**ADDENDUM NO. 3
CITY OF PEORIA
MacArthur Highway Improvement Project
June 5, 2025**

Re: Addendum for Bid Package, **MacArthur Highway Improvement Project**, Peoria, IL

PROPOSED TYPICAL SECTION - JOHN H GWYNN JR AVE

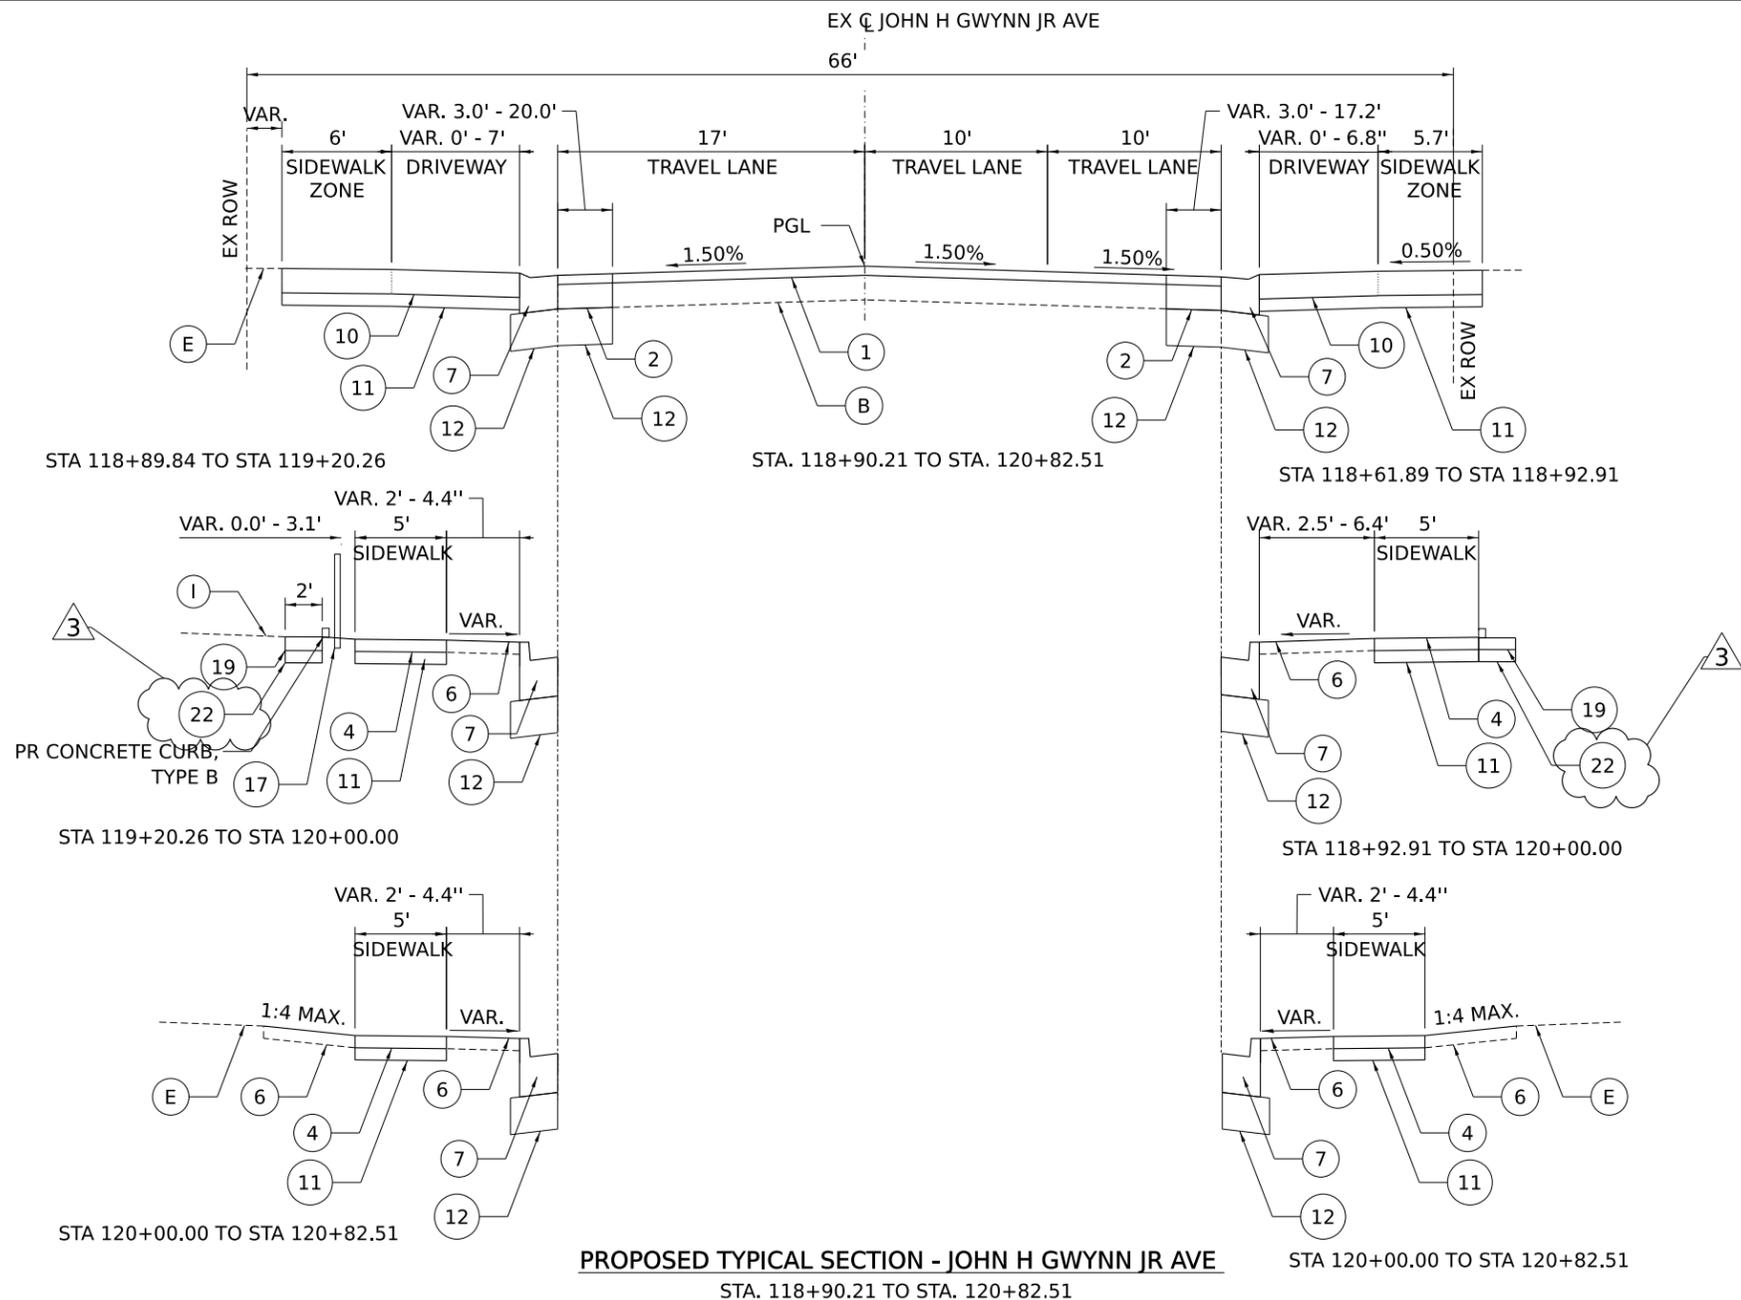
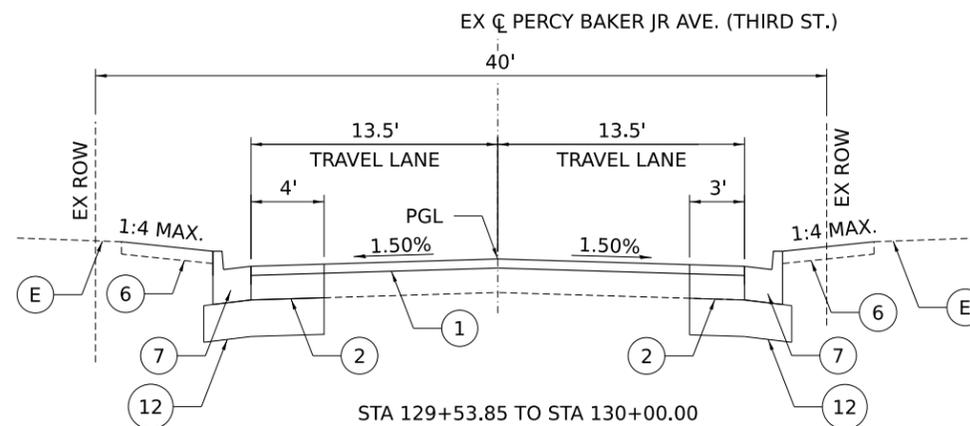
6. Correction to typical sections – subbase callout under INCIDENTAL HMA changed from 4 INCH to 6 INCH.
 - a. Typical sections (sheets 23, 24, 29, 32)
7. Correction to bottom elevation of S96

F.A. RTE.	SECTION	COUNTY	TOTAL SHEETS	SHEET NO.
		PEORIA	405	48
CONTRACT NO.				
ILLINOIS FED. AID PROJECT

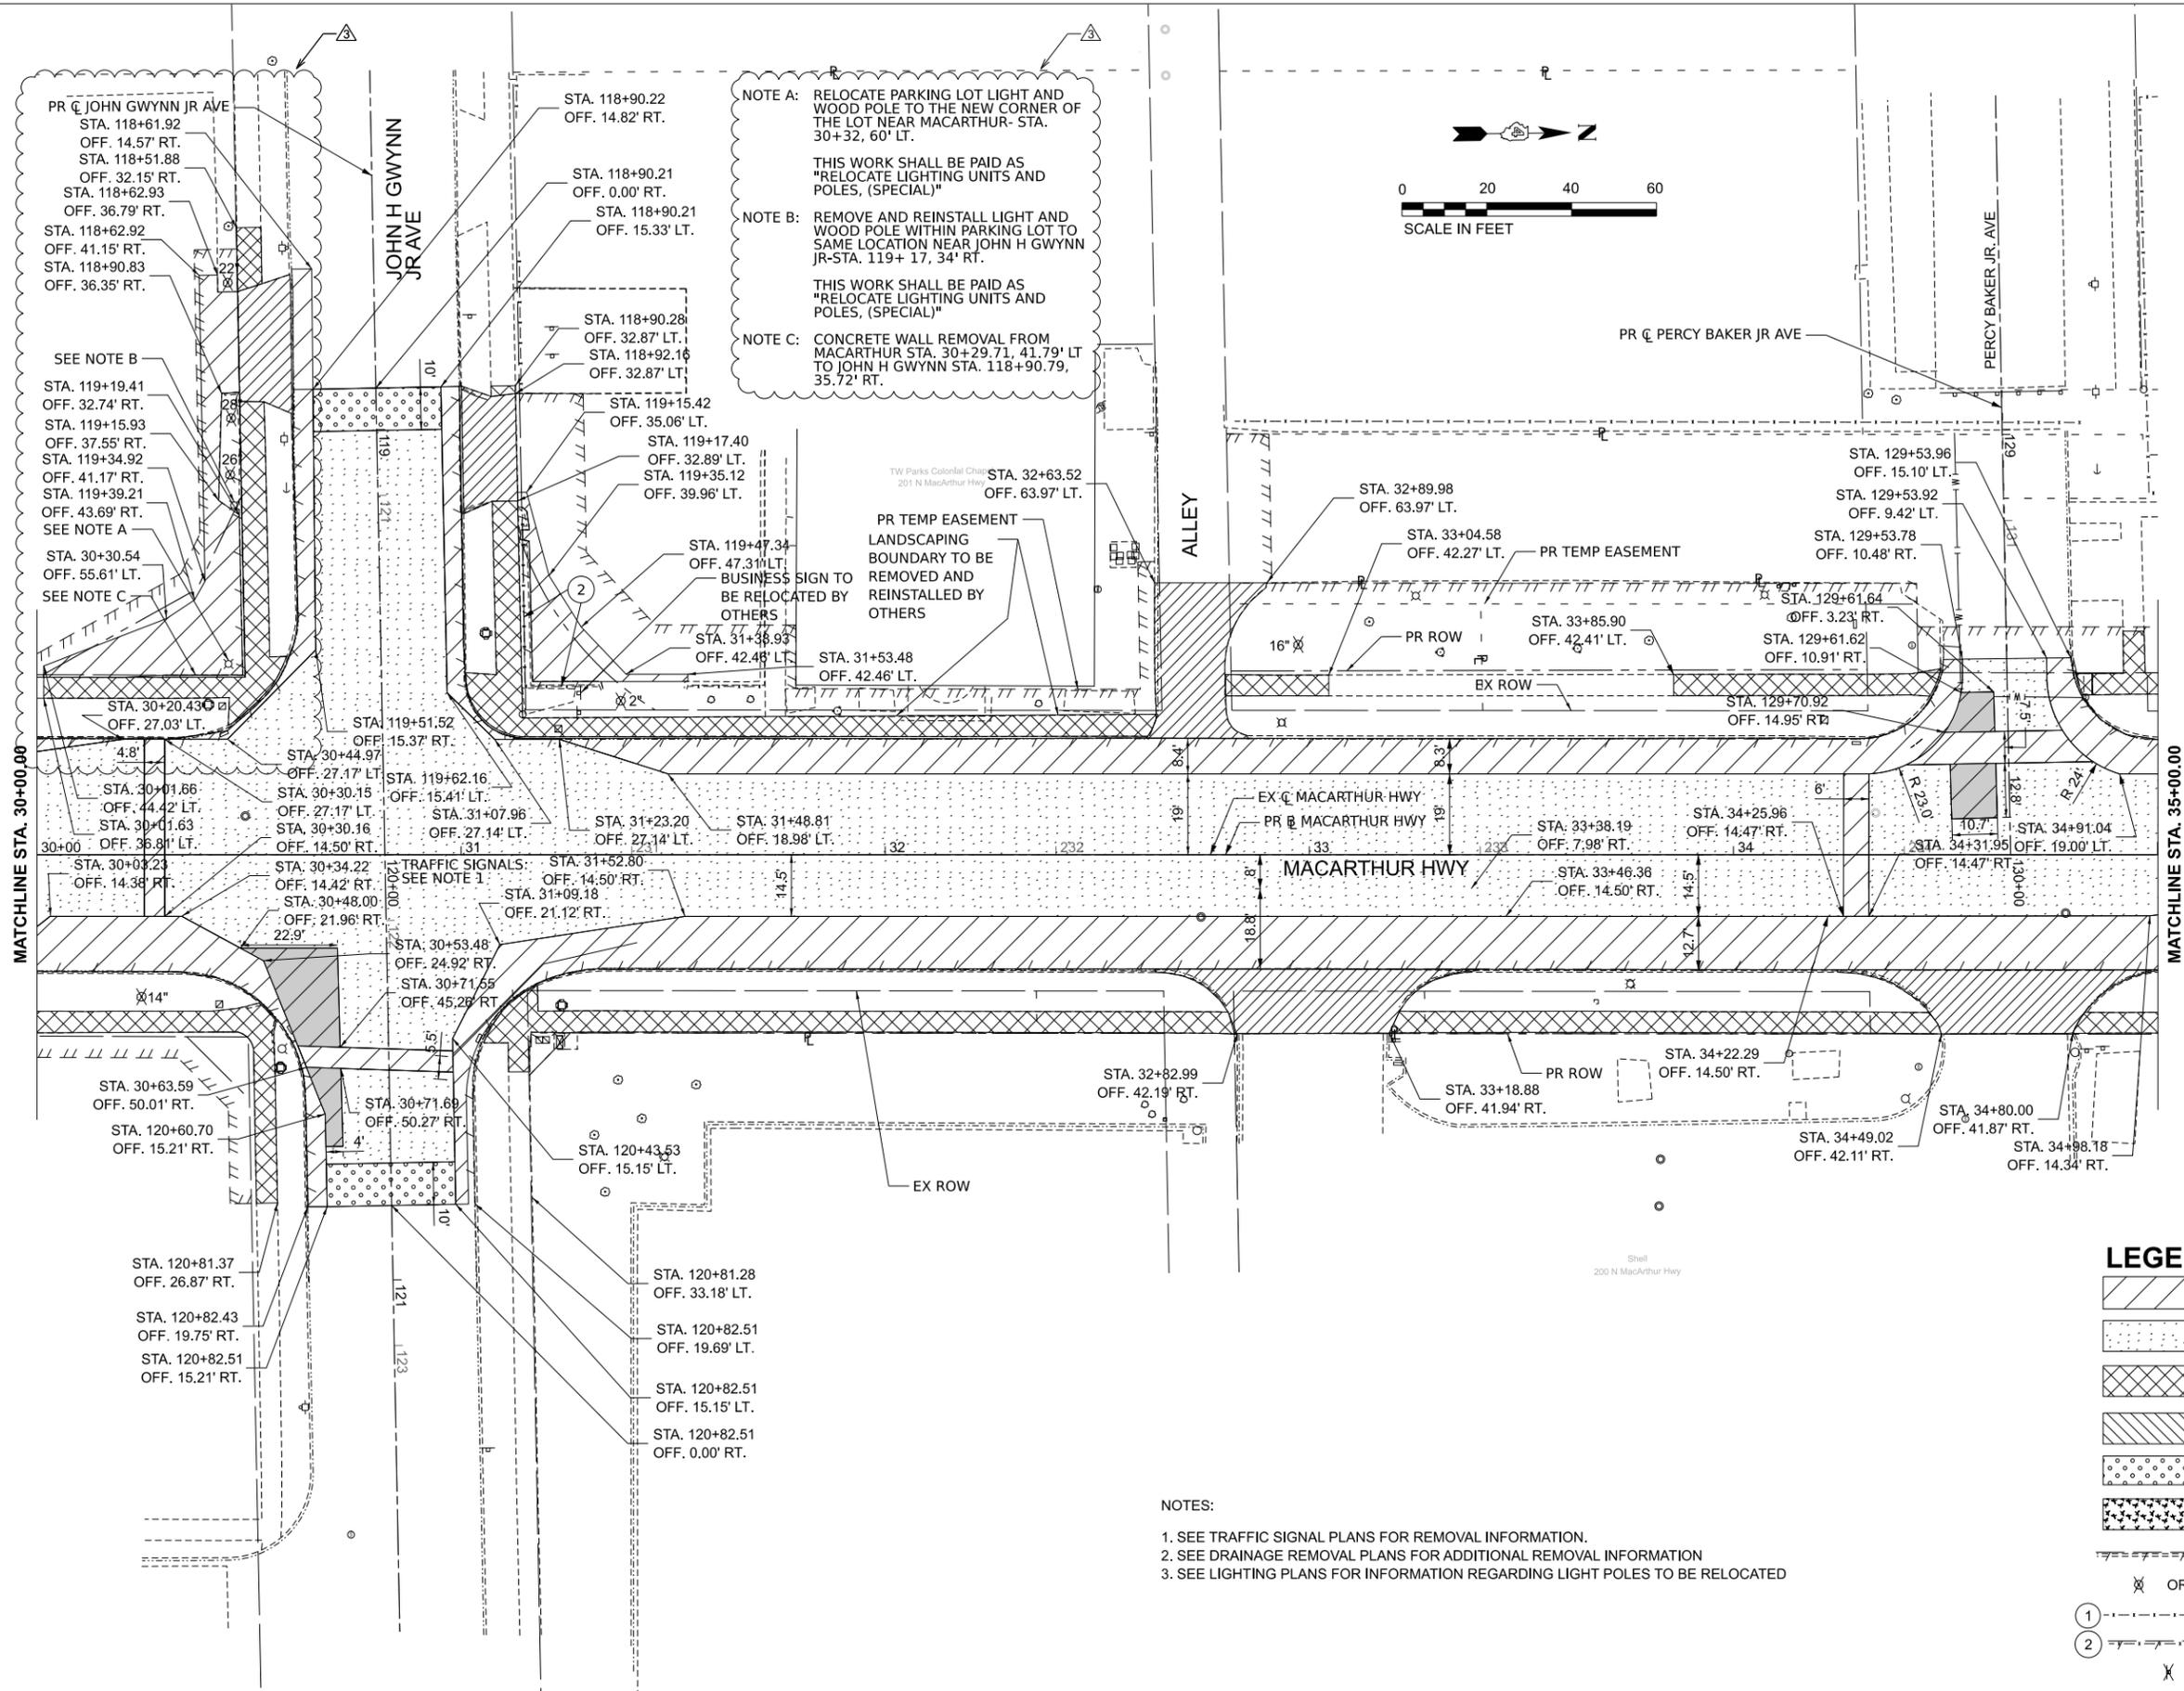
- a. Summary of Quantities (sheets 4, 5, 7, 11, 12)
 - b. Typical Sections (sheets 32)
 - c. Schedules of Quantities (sheets 34, 35, 38, 39)
 - d. Removal Plan (sheet 48)

A note has been added to plan sheet 240 to clarify RELOCATE LIGHTING UNITS AND POLES, (SPECIAL). This points to sheet 48 – Notes A and B, which also address this item. The quantity has been increased to 2 EACH. This item refers to the existing wood poles with lights on them in the parking lot in the southwest corner of MacArthur and John Gwynn.

NOTE A: RELOCATE PARKING LOT LIGHT AND WOOD POLE TO THE NEW CORNER OF THE LOT NEAR MACARTHUR- STA. 30+32, 60' LT.
 THIS WORK SHALL BE PAID AS "RELOCATE LIGHTING UNITS AND POLES, (SPECIAL)"

NOTE B: REMOVE AND REINSTALL LIGHT AND WOOD POLE WITHIN PARKING LOT TO SAME LOCATION NEAR JOHN H GWYNN JR-STA. 119+ 17, 34' RT.
 THIS WORK SHALL BE PAID AS "RELOCATE LIGHTING UNITS AND POLES, (SPECIAL)"

F.A. RTE.	SECTION	COUNTY	TOTAL SHEETS	SHEET NO.
		PEORIA	405	68
CONTRACT NO.				
ILLINOIS FED. AID PROJECT

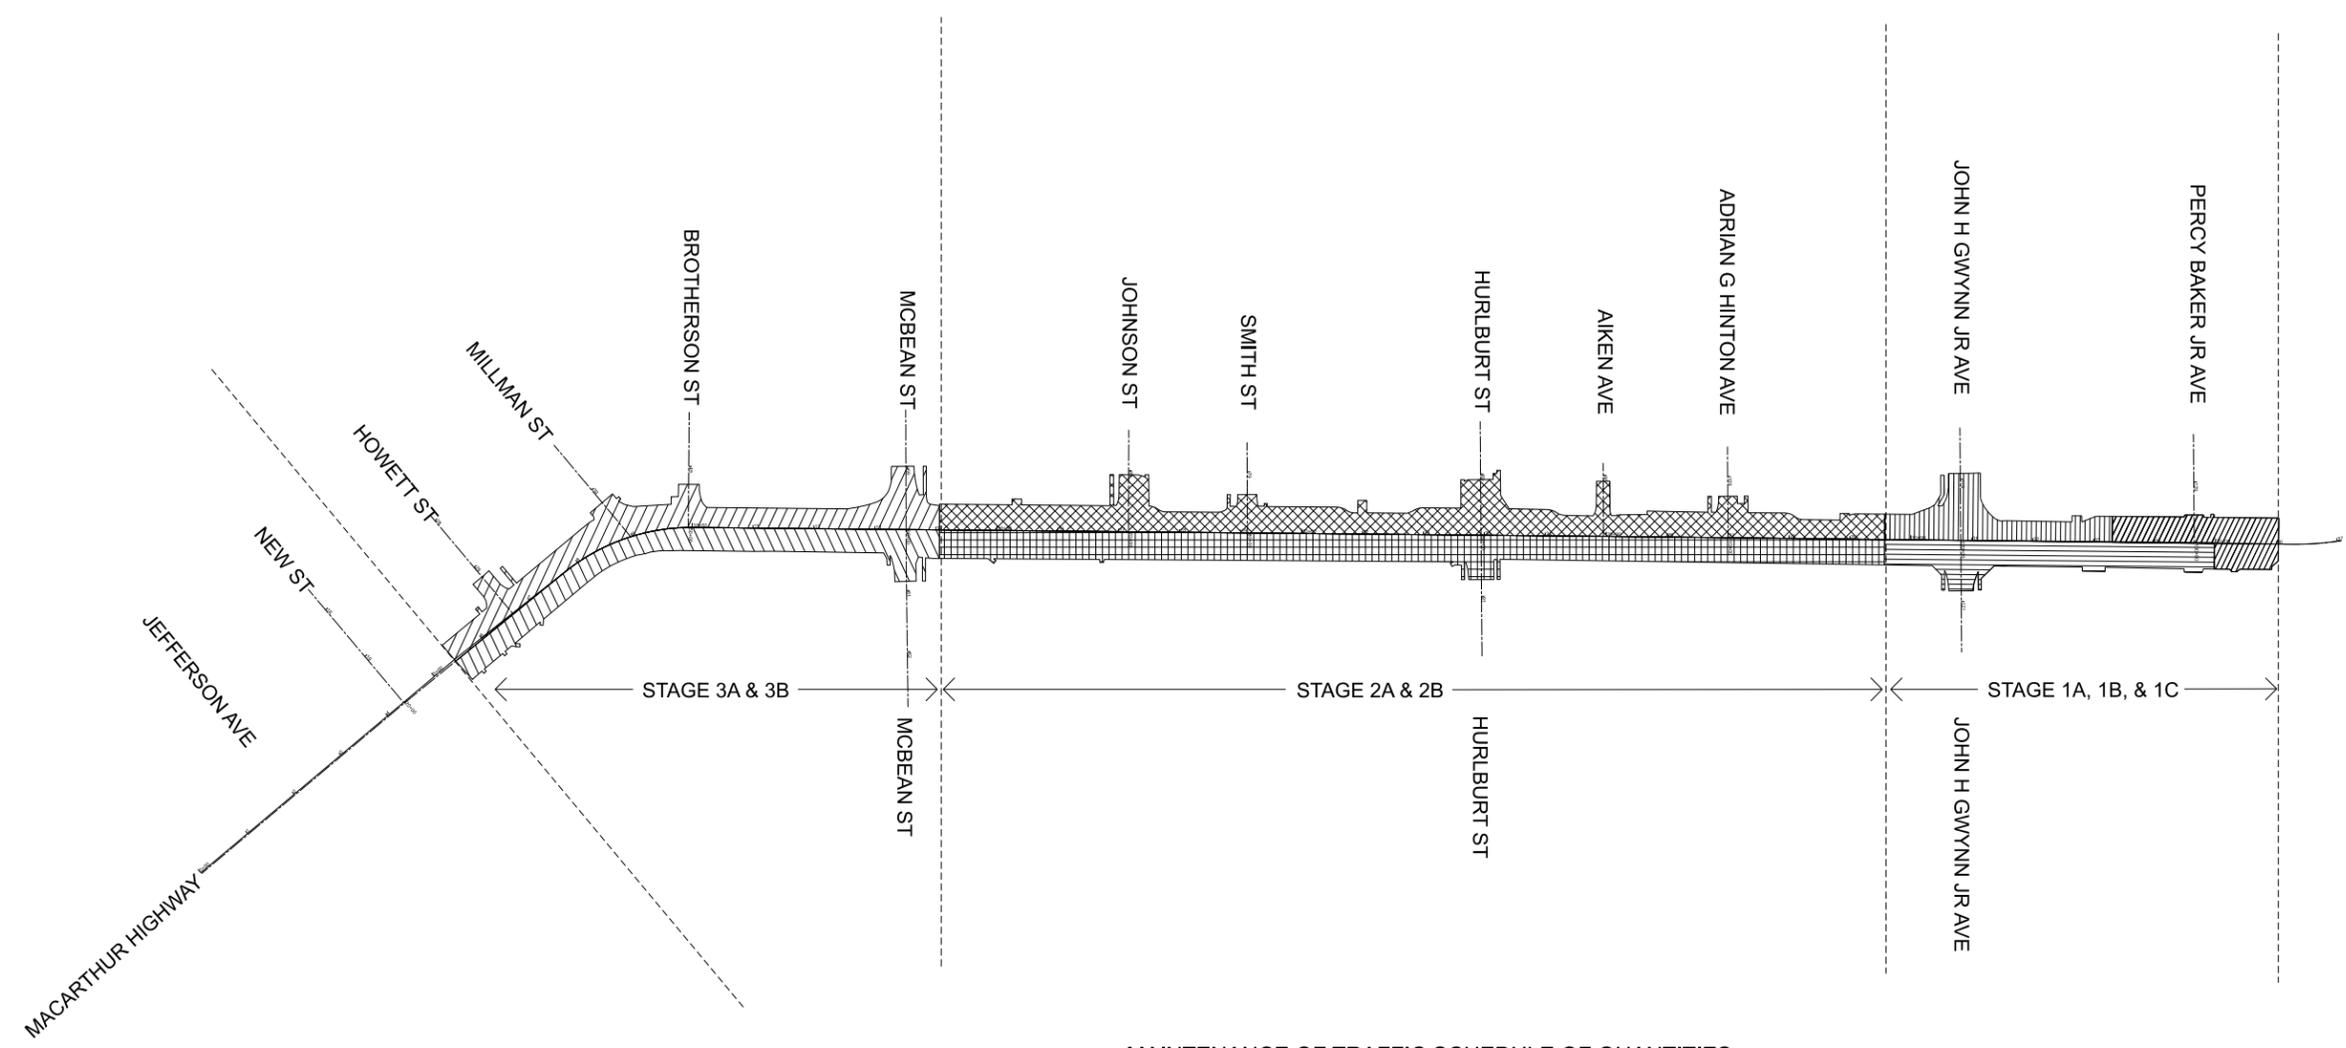
- a. Summary of Quantities (sheet 12)
 - b. Schedules of Quantities (sheet 34)
 - c. Maintenance of Traffic Staging Overview (sheet 68)
5. Revised Lighting Plan to clarify work of specific pay items

Question: Do you have a breakdown of the 11,000sf of temporary sidewalk? Lengths, widths, and locations would be helpful for bidding other than total quantity by stage. Also based on the pedestrian detour sections of the MOT plan, pages 68-115, it reads like you are closing sidewalk on the part you are working on and using existing and new sidewalk or path for pedestrians on the other or completed parts so this quantity seems excessive.

Response: Temporary sidewalk is intended for use as needed to maintain access to businesses and homes within the project limits during construction. The actual placement of temporary sidewalk will be dependent on the Contractor's means and methods, as directed by the Engineer, and in coordination with the needs of the parcel. The provisional quantity has been

revised to reflect the following design assumptions:

- 5' wide temporary sidewalk
- Approximately 25' of length provided at isolated entrances/connections along replaced sidewalk
- Continuous length along buildings with multiple entrances
- Continuous length adjacent to the Peoria Housing Authority properties (~Sta. 6+00 to 13+30 RT)
